CARILION
Health System

**RIVERSIDE
CORPORATE CENTRE
OFFICE BUILDING**

SITE LAYOUT AND UTILITY PLAN

CS101

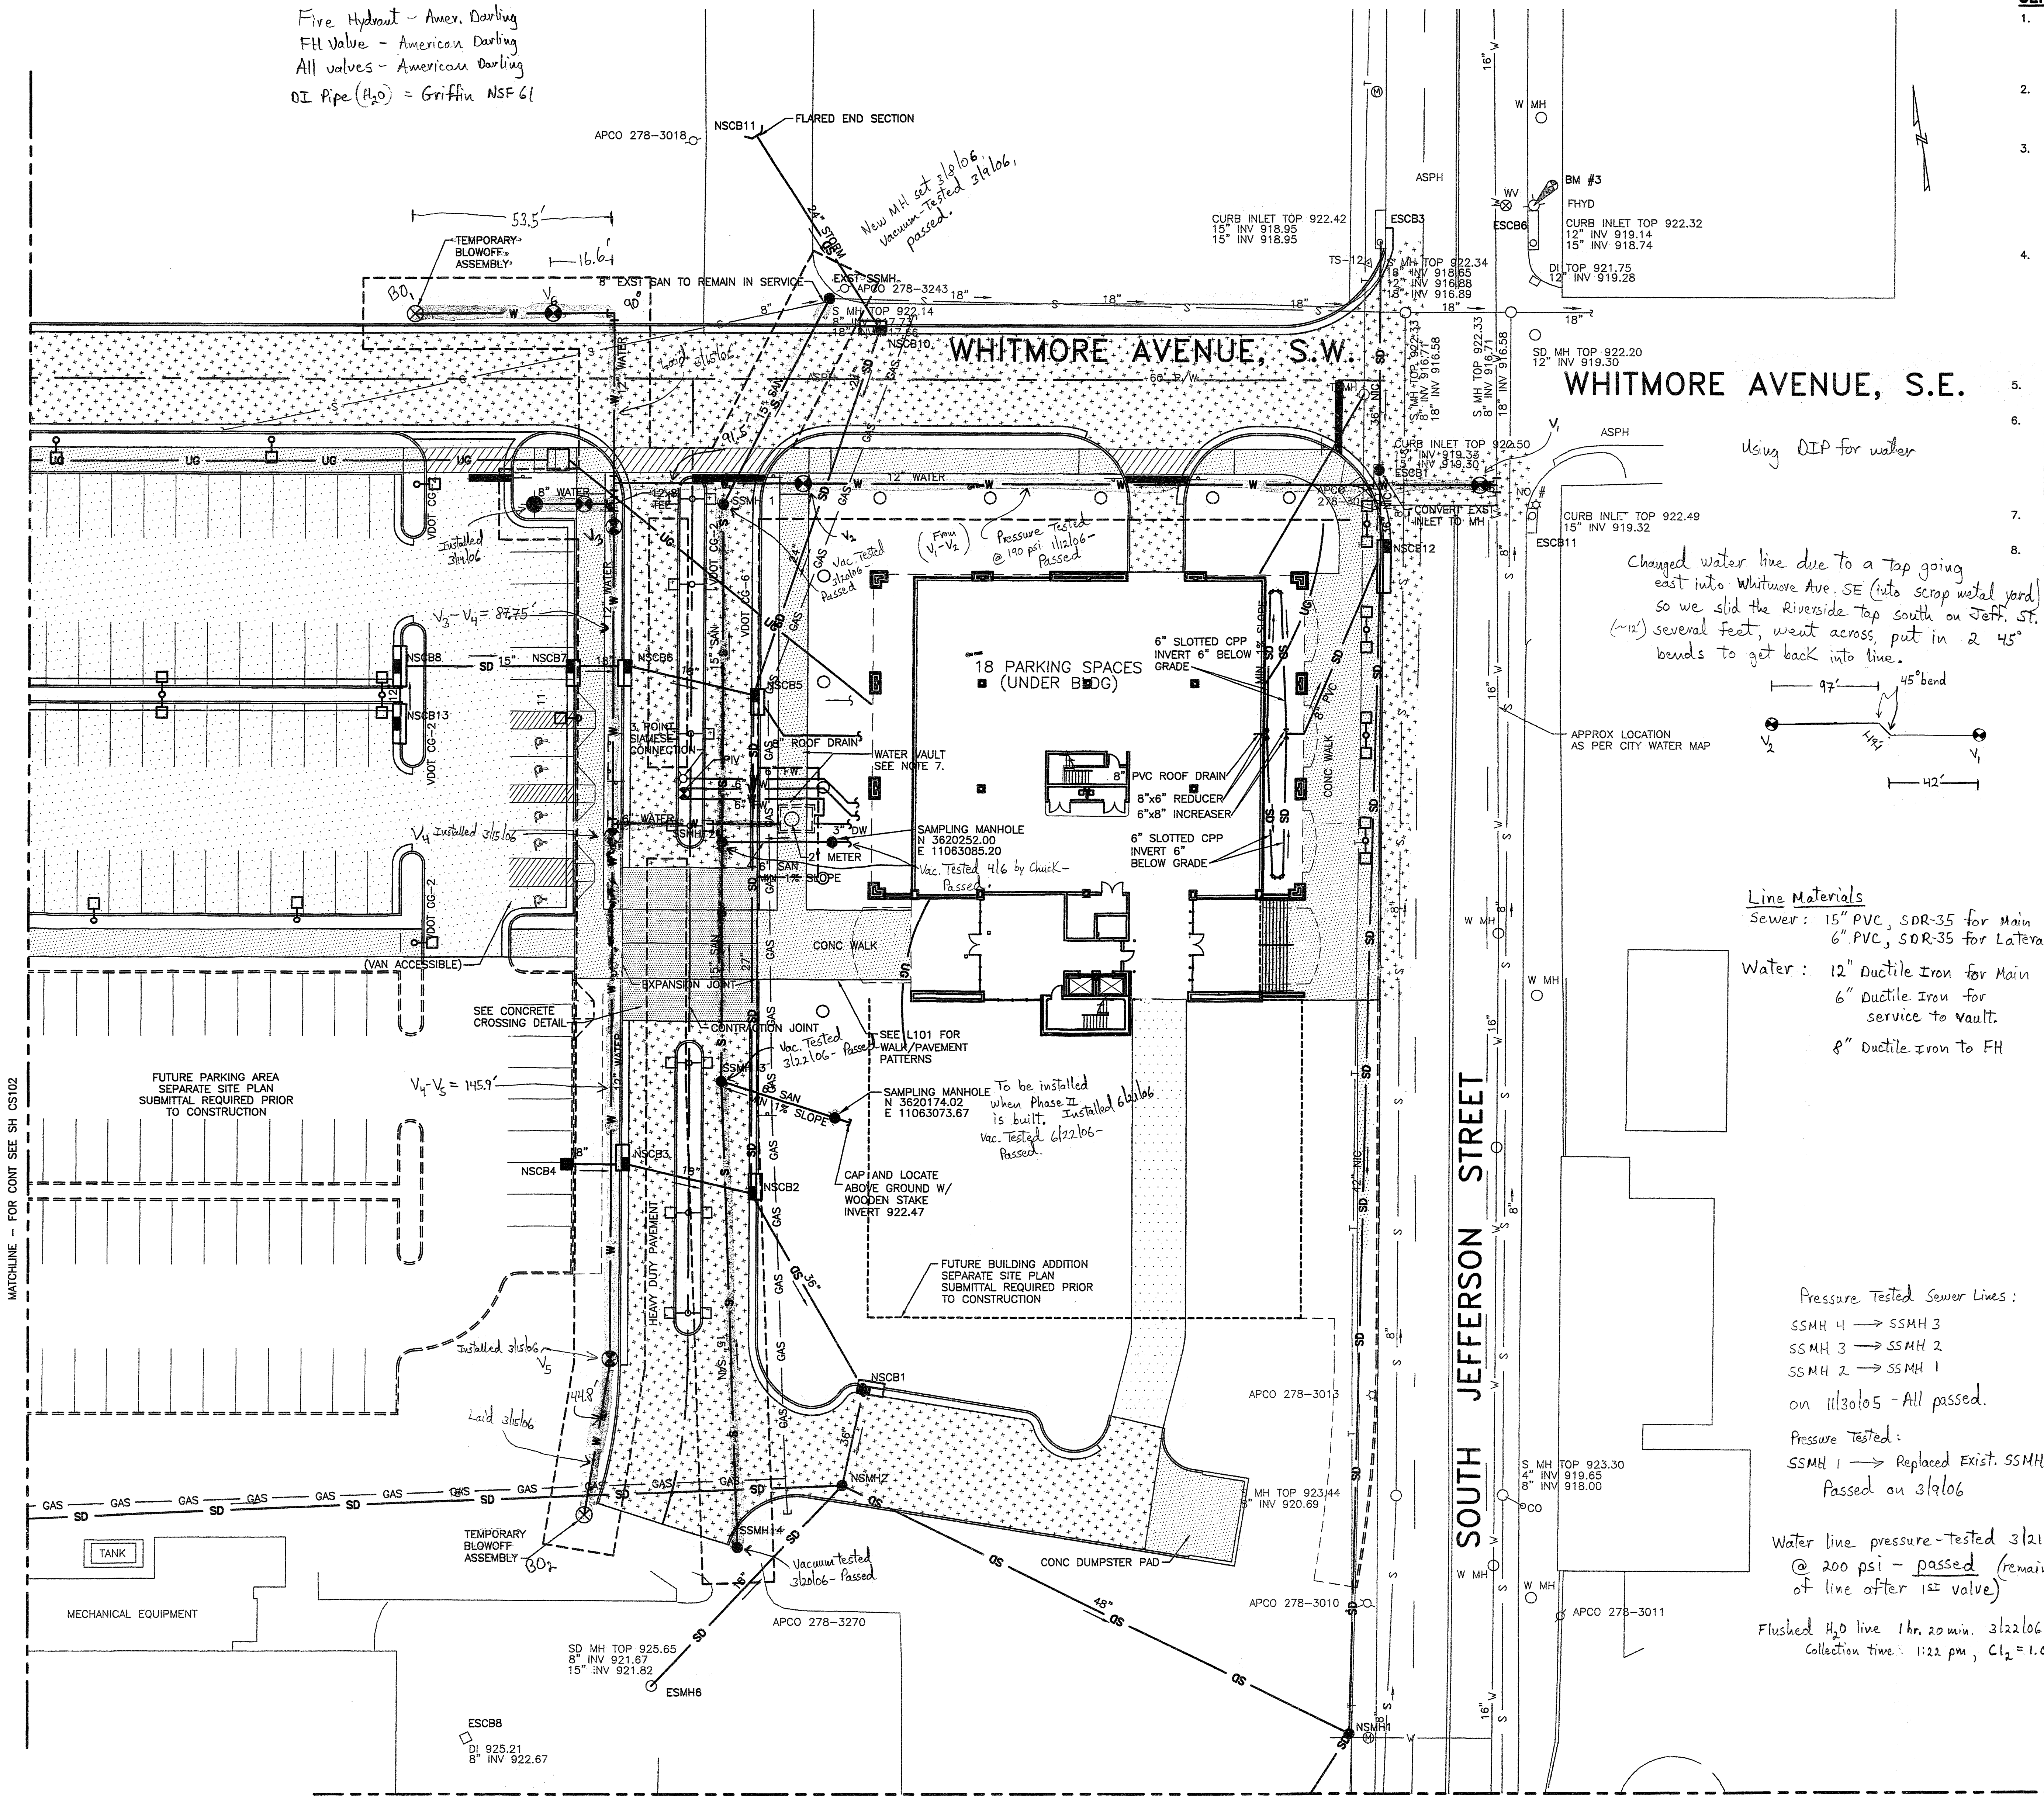
Fire Hydrant - Amer. Darling
FH Valve - American Darling
All valves - American Darling
OI Pipe (H_2O) = Griffin NSF 61

8.
Changed water line due to a tap going
east into Whitmore Ave. SE (into scrap metal yard)
so we slid the Riverside tap south on Jeff. St.
(~12') several feet, went across, put in 2 45°
bends to get back into line.

Pressure Tested Sewer Lines:

SSMH 4 $\rightarrow$ SSMH 3
SSMH 3 $\rightarrow$ SSMH 2
SSMH 2 $\rightarrow$ SSMH 1

on 11/30/05 - All passed.

Pressure Tested:
SSMH 1 $\rightarrow$ Replaced Exist. SSMH
Passed on 3/9/06

Water line pressure-tested 3/21/06
@ 200 psi - passed (remainder
of line after 1st valve)

Flushed H_2O line 1 hr. 20 min. 3122106
Collection time: 1:22 pm, $Cl_2 = 1.0$

12" DIP = 640.17'
8" DIP = 21.33'
6" DIP = 57.67'

$V_{\text{valve}_1} \rightarrow 1^{\text{st}} 45^\circ$	: 42.0
$1^{\text{st}} 45^\circ \rightarrow 2^{\text{nd}} 45^\circ$	: 19.0
$2^{\text{nd}} 45^\circ \rightarrow V_2$	: 97.0
$V_2 \rightarrow 12 \times 12 \text{ Tee}$	: 91.5
$12 \times 12 \text{ Tee} \rightarrow 90^\circ$	: 48.7
$90^\circ \rightarrow V_6$	: 16.6
$90^\circ \rightarrow B_1$	: 53.5
$12 \times 12 \text{ Tee} \rightarrow 12 \times 8 \text{ Tee}$	: 3.75
$12 \times 8 \text{ Tee} \rightarrow FH \text{ valve}$	: 14.7
$12 \times 8 \text{ Tee} \rightarrow FH$	: 21.3
$12 \times 12 \text{ Tee} \rightarrow V_3$	: 10.0
$V_3 \rightarrow 12 \times 6 \text{ Tee}$	: 83.0
$12 \times 6 \text{ Tee} \rightarrow \text{Vault}$	: 57.7
$V_3 \rightarrow V_4$	: 87.75
$V_4 \rightarrow V_5$	: 145.9
$V_5 \rightarrow B_2$	: 44.8

Exist. MH $\rightarrow$ MH 1 64.75'
MH 1 $\rightarrow$ MH 2 95.58'
MH 2 $\rightarrow$ Sampl. MH 25.5'
MH 2 $\rightarrow$ MH 3 65.25'
MH 3 $\rightarrow$ Stub-out 20.0'
MH 3 $\rightarrow$ MH 4 131.25'

Exist.	MH	8.67
MH 1	8.58'	
MH 2	7.50'	
MH 3	7.00'	
MH 4	6.58'

<u>Lateral</u>	<u>Depth</u>
MH 2	4.83'
MH 3	5.00'
